DEVELOPMENT REVIEW COMMITTEE (DRC) COMMENT REPORT

PROJECT NAME: Suncrest Court – Block 1

CASE NUMBER: R18026

REQUEST: Site Plan Level II Review: 28 Multifamily Residential Units

- d. **Existing Stormwater Asset Map possibly affected by the Proposed Development:**

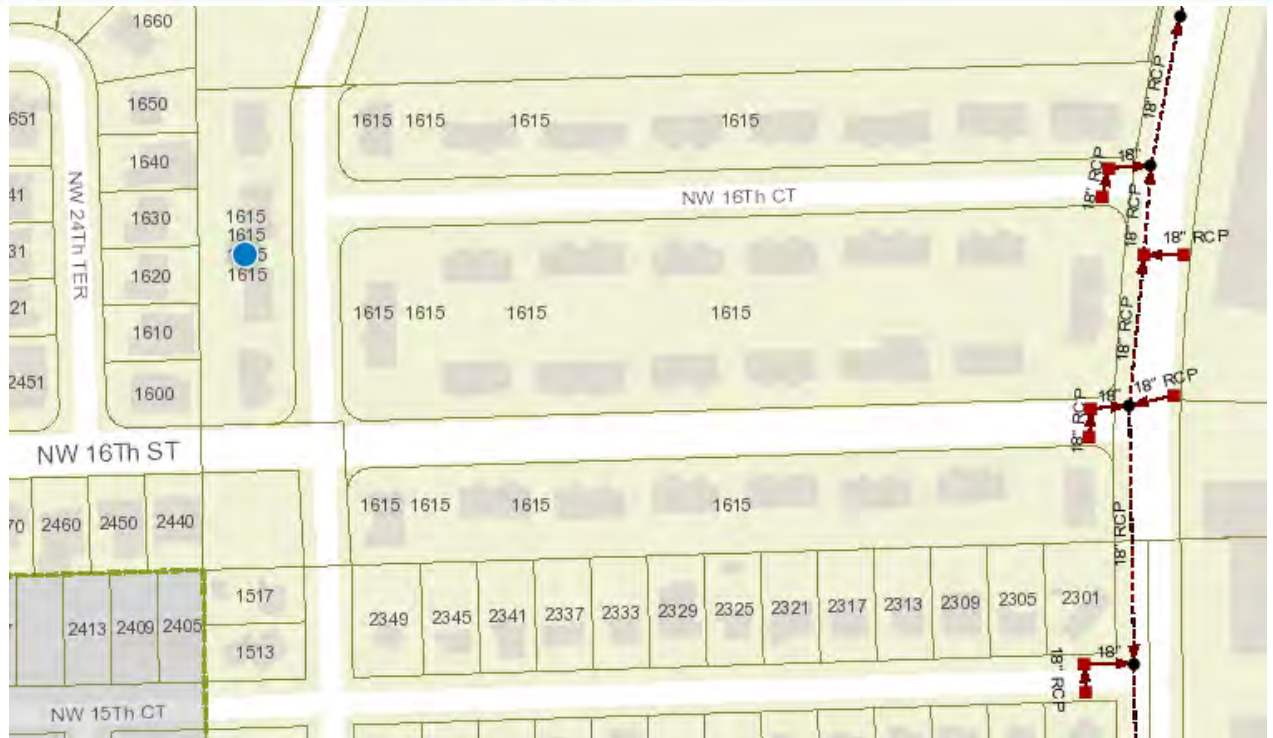
14. The City owns and maintains stormwater infrastructure adjacent to the proposed development as shown with green line work in the map provided at the end of this report. The following comments pertain to possible impacts of the proposed development and/or construction activities to the existing condition of the City's stormwater assets. The applicant shall provide an itemized response letter addressing the following comments:

- a. Please note that no private stormwater infrastructure (drainage pipes, wells, or basins,) can be constructed in City Right of Way or in City drainage easements. Please remove any proposed stormwater systems that are not in compliance with this requirement or provide appropriate documentation of City Rights-of-Way or easement vacated to allow the construction of private underground utilities.

- b. If the development is proposing to remove street swales and construct parallel parking and concrete curbs as shown on the overall site layout, the Civil engineer shall address the City street flood protection criteria & maintenance of City's stormwater assets. Please coordinate requirements with Engineering.
